Ginna Station

UFSAR Section 6.2.4 and Tables 6.2-13, 6.2-14 and 6.2-15 Changes

NSL-0000-SA024

Revision 3

Figure 6.2-38
 Component Cooling Water to Reactor
 Coolant Pump 1B, Penetration No. 128

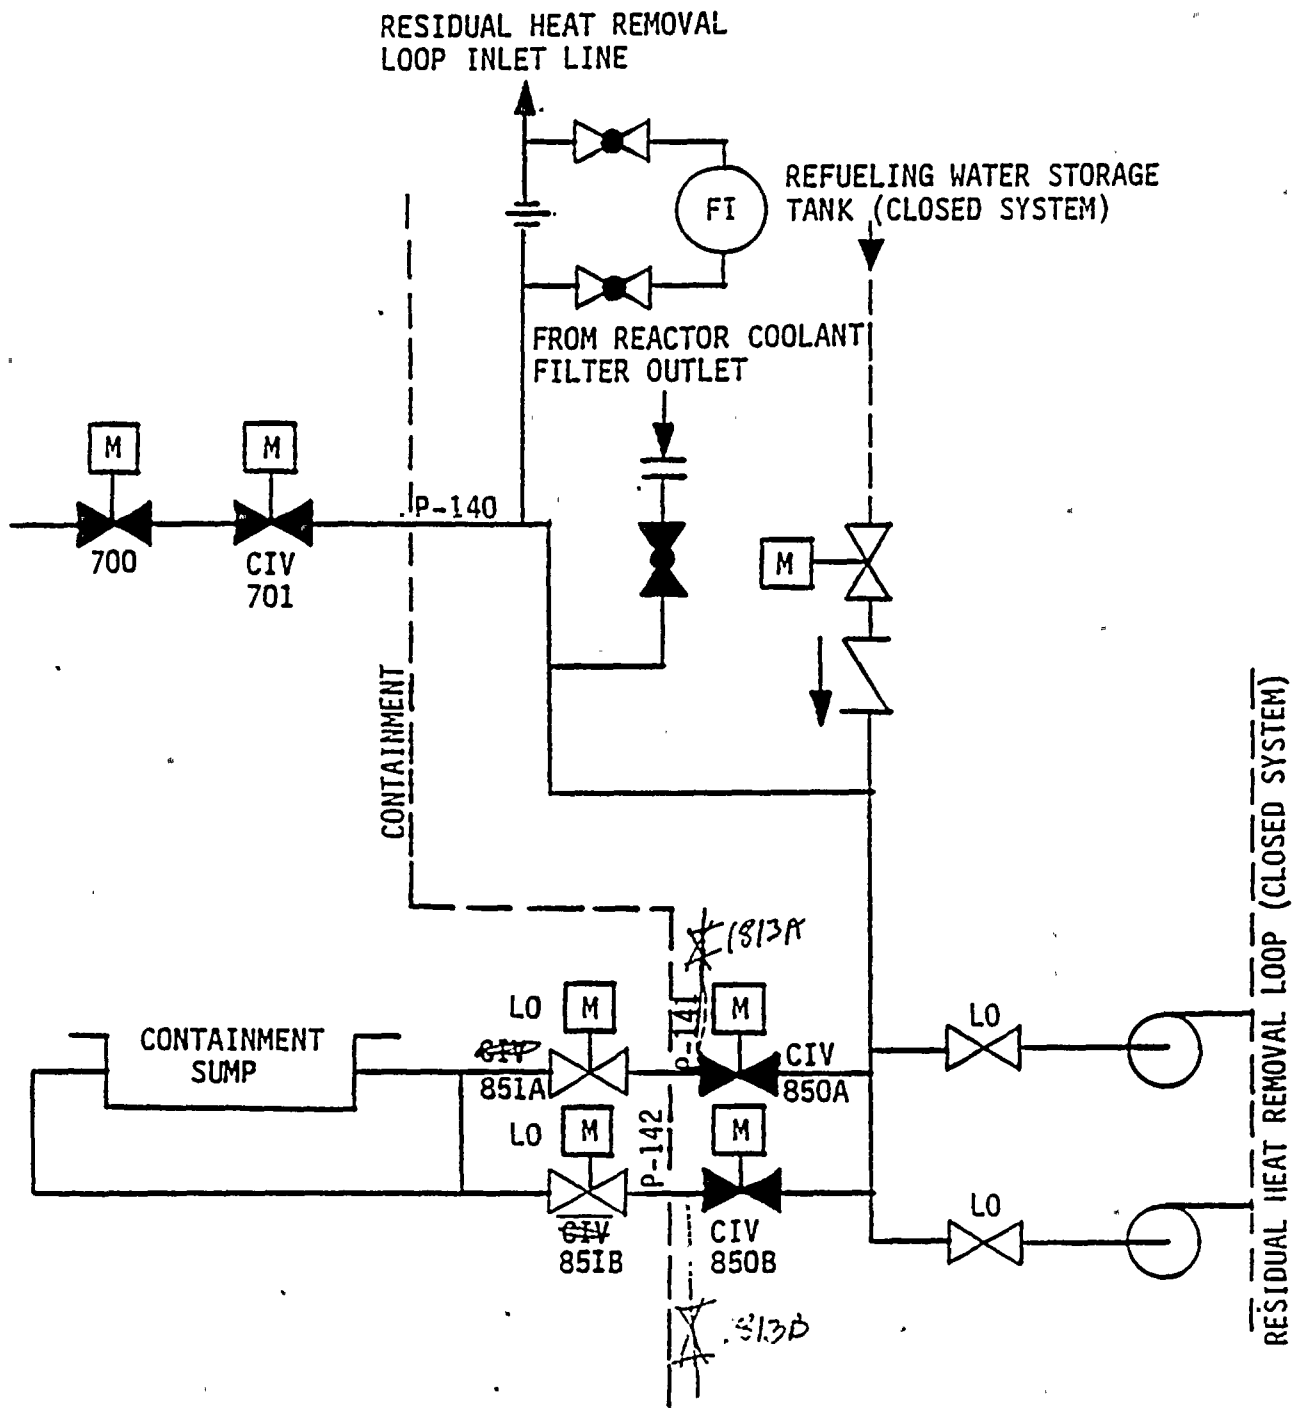
31.	Penetration 128 - (1) Changed <u>Position Indication In Control Room</u> from "Yes" to "R/B" for valve 749B; (2) Changed <u>Position At Cold Shutdown</u> from "O" to "C" for valve 749B; (3) Global Notes 1, 2, and 4 for valve 750B; (4) Changed <u>Maximum Isolation Time</u> from "60" to "NA" for valve 749B.	(1) Minor clarification only. No technical change. (2) Update for better representation of system configuration since RCPs are not operating during cold shutdown conditions. (3) No technical change. (4) Correction of typographical error. No technical change.

Figure 6.2-42
 Residual Heat Removal Pump Suctions
 Penetration Nos. 140, 141, 142

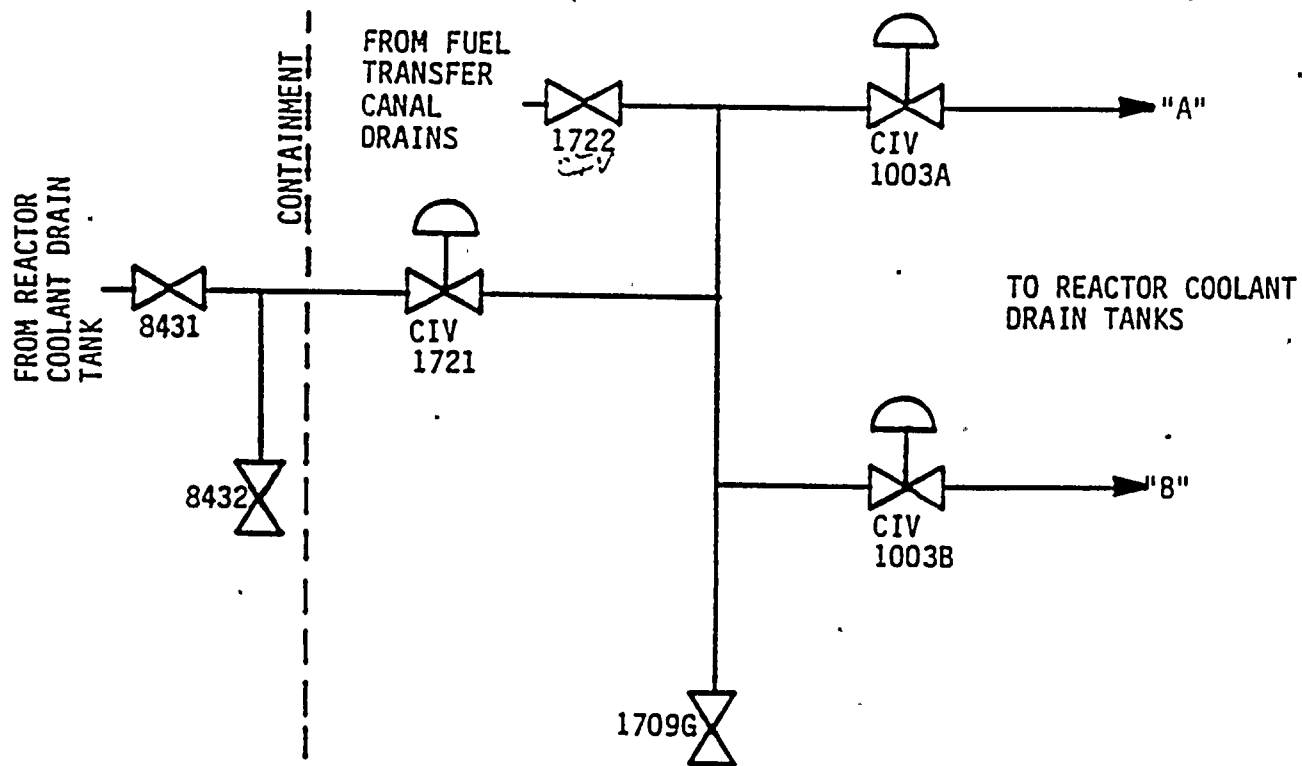
- (d) 123 (bottom) - Added valve 1600A. See explanation for 3.3.2.7 (b) above.
- (e) Penetration 141 - Deleted valve 851A and added valve 1813A. Valve 851A does not meet the selection criteria for 10CFR50 Appendix J, Section IIH, items 1 through 4. Consequently, the valve was deleted from the table. Valve 1813A was previously missing from the table. This valve is locked-closed with its breaker locked open.

- (f) Penetration 142 - Deleted valve 851B and added valve 1813B. See explanation for 3.3.2.7 (e) above.
- (g) Penetration 205 - Added valve 955. See explanation for 3.3.2.7 (b) above.

3.4.1 Section 6.2.4.4.2.2 - The discussion concerning line 140 was revised to show that only one motor-operated valve is provided for this penetration instead of the two previously listed. There are in-fact two motor-operated valves in this line; however, credit is only taken for one of these valves as an isolation barrier (see UFSAR Table 6.2-13 and Reference 2.7). Consequently, the discussion was modified to reflect only a single valve.

Figure 6.2-55
 "A" and "B" Hydrogen Recombiner
 Oxygen Makeup, Penetration No. 210

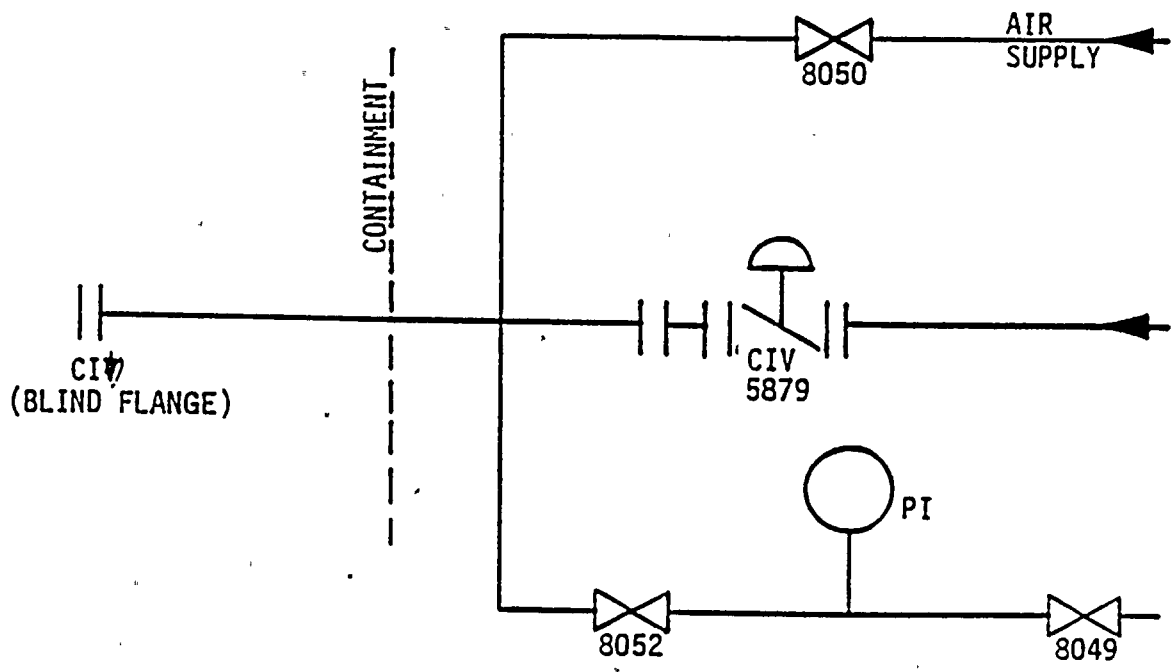
- (j) Penetration 210 - Added valves 10214S1 and 10215S1. These valves were previously missing from the table, but receive an isolation signal.

Figure 6.2-68

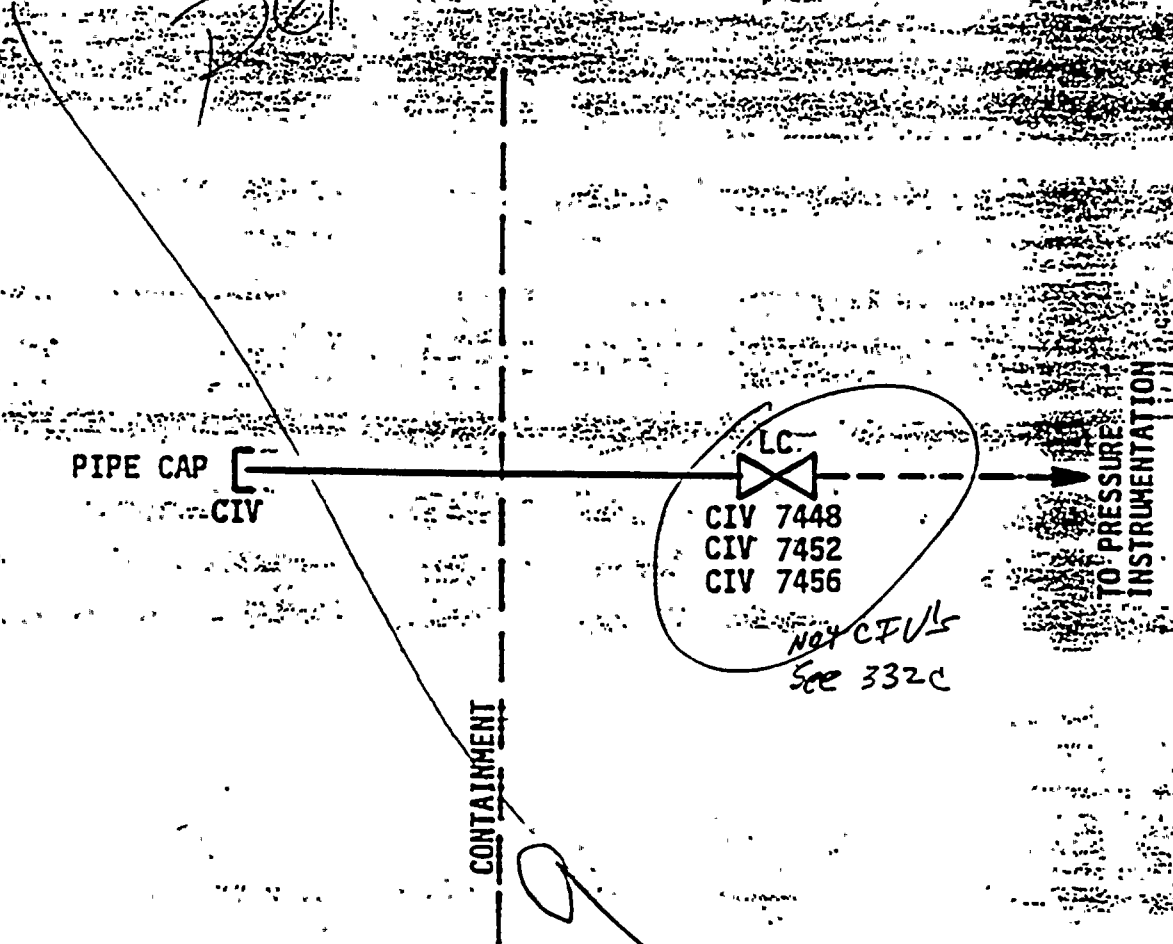
Delete Page
